Design Modifications to Stage 1B Basement, Barangaroo South

*State Significant
Development
Modification Assessment
(SSD 6960 MOD 2)*

July 2019

Figure 5 | Comparison of approved plan (above) and proposed plan (below) with the proposed changes bubbled in red (Base source: EIS SSD 6960 MOD 2)

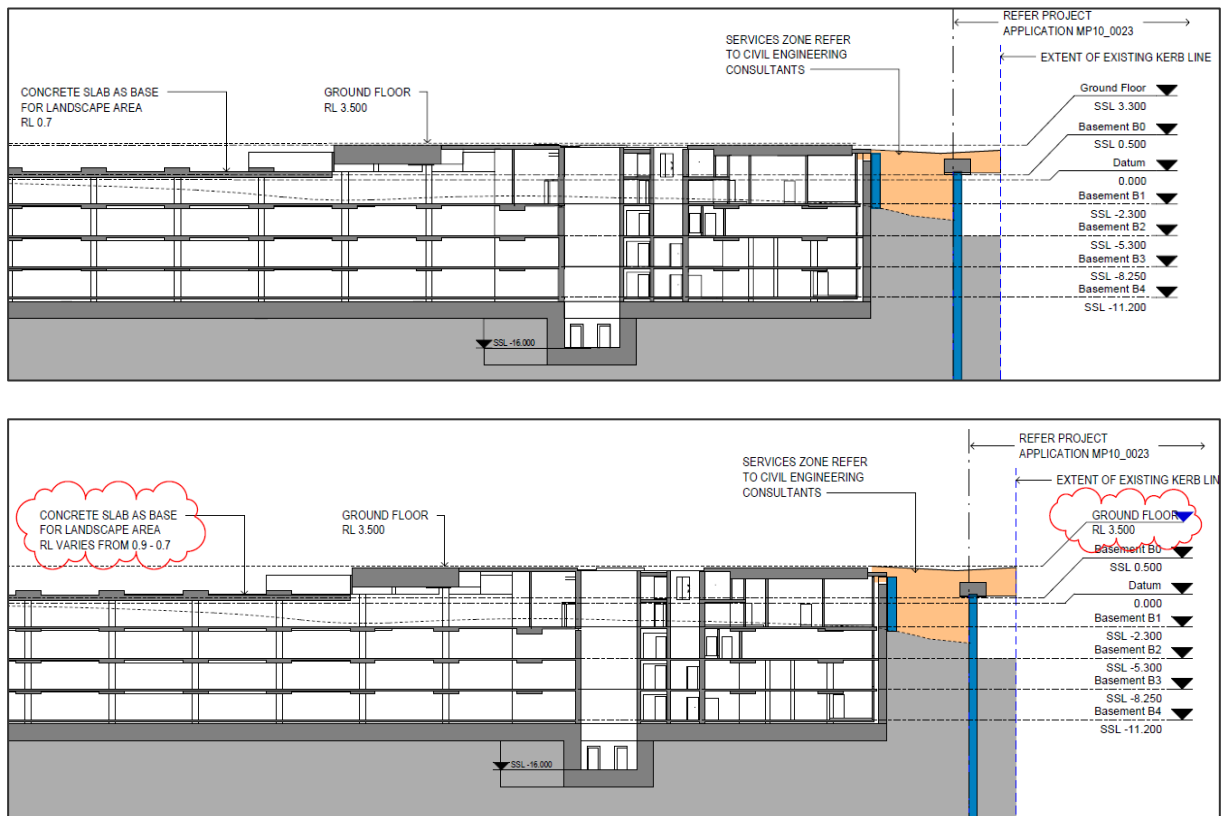
On 6 June 2019, the Applicant lodged a modification application (SSD 6960 MOD 2) seeking approval under section 4.55(1A) of the EP&A Act, to amend the SSL of the approved basement slab from a consistent level of RL 0.7 to variable levels between RL 0.7 and RL 0.9.

The amended levels will align with the levels of the public domain works approved under SSD 7944 and the amendments proposed under modification application SSD 7944 MOD 1. The levels will also match the future raising of Hickson Road by Infrastructure NSW (formerly known as NSW Barangaroo Delivery Authority). The amended levels will also assist with stormwater flows throughout Hickson Park by providing grades that allow the deep soil area to drain naturally by gravity above the slab level.

An extract showing the approved plan and the proposed plan is provided in **Figure 5**.

- the proposed changes to the SSL of the approved basement slab are incrementally minor, however the overall implications of these changes result in Hickson Park becoming increasingly inaccessible through raising the levels and introducing a seating wall that creates a barrier and mounding the grass. The current proposal (SSD 7944 MOD 1) to elevate levels of Hickson Park result in a 500mm high wall to the Hickson Road edge, separation between the public domain and the park, poor permeability and connectivity, and the reduction in universal access for all users. Meanwhile the elevated park levels to Barangaroo Avenue result in walls up to 700 mm high.
- it is recommended that a condition be imposed to 'cap' future level changes with a maximum ground level and structural slab level.

The Department notes plans submitted with the modification application are consistent with the construction drawings approved under Condition A3. Although, the modification application proposes to increase the SSL of the slab by a maximum of 200 mm, any potential reduction in deep soil zones can be offset by the modification proposed under SSD 7944 MOD 1, which seeks to raise Hickson Park by a maximum of 400 mm to allow for integration with the future upgrade of Hickson Road. This will equate to approximately 60 m³ of additional deep soil.

Additionally, the introduction of grades to the surface slab level does not negatively impact upon the minimum depths for planting specified with the deep soil zone. Generally, the inclusion of grades to the basement slab is supported, because effective drainage is essential to sustain large tree planting on slabs.

Council raised concerns that the proposed modification will impact the ground levels of Hickson Park. However, the proposed modification does not seek to alter the ground levels of Hickson Park as the modifications proposed to Hickson Park are being considered under modification application SSD 7944 MOD 1.

The modifications proposed under SSD 6960 MOD 2 will not pre-empt the determination of SSD 7944 MOD 1 as the proposed changes to the SSL of the approved basement slab are minor in nature and can proceed as a standalone modification.

Based on the above, the Department concludes that the modification to the SSL of the basement slab will not compromise the required deep soil zones and the future delivery of Hickson Park.
